**Draft supplements to UN/ECE Regulation 67-01 series
with a view to update the requirements on the LPG filling unit**

Transmitted by the Expert from the European LPG Association (AEGPL)

Figure 3: connecting area of the light vehicle Euro filling unit

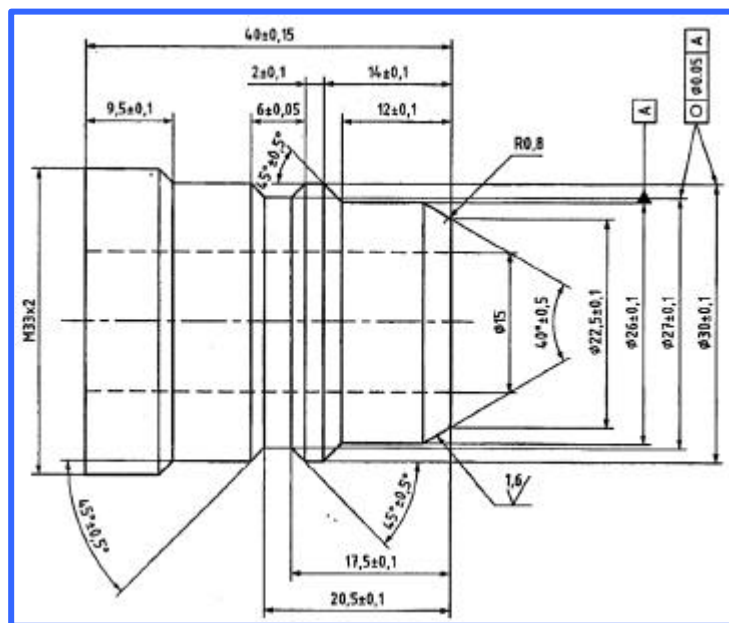
6.15.10.6 Specific provisions regarding the light vehicle Euro filling unit (Annex 9 - Figure 3):

- The dead volume between the front sealing surface and the front of the non-return valve shall not exceed 0,1 cm³;
- The flow through the connector at a pressure difference of 300 kPa shall be at least 60 L/min, if tested with water.

Figure 5: connecting area of the heavy duty vehicle Euro filling unit

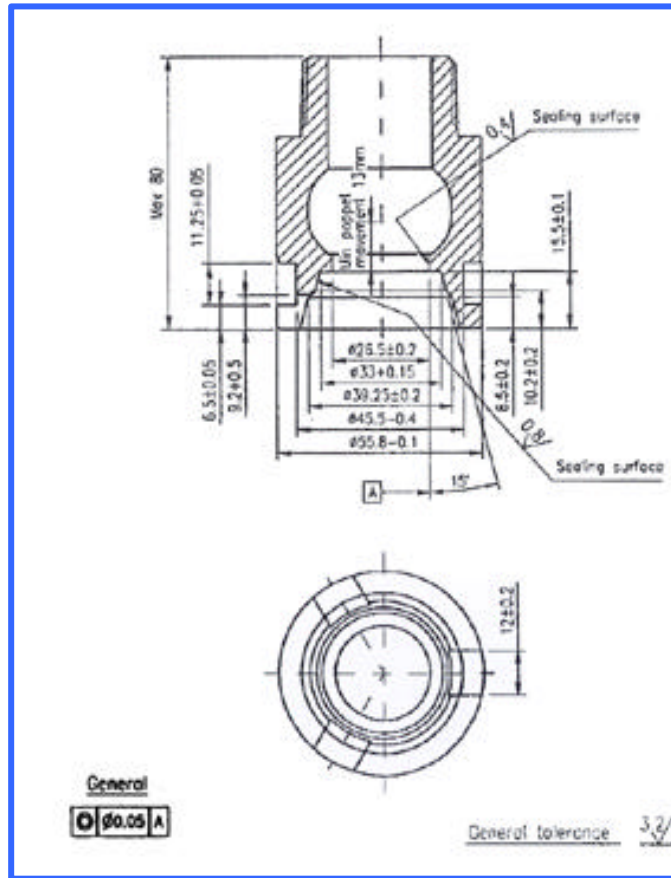
The filling unit shown in the figure ~~3~~ 5 is only applicable for motor vehicles of categories M2, M3, N2, N3 and M1 having a maximum total mass > 3,500 kg. */

6.15.10.7 Specific provisions regarding the heavy-duty vehicle Euro filling unit (Annex 9 - Figure 5) :

- The dead volume between the front sealing surface and the front of the non-return valve shall not exceed 0,5 cm³;
- The flow through the filling unit, with the non-return valve mechanically opened, at a pressure difference of 500 kPa shall be at least 200 L/min, when tested with water.
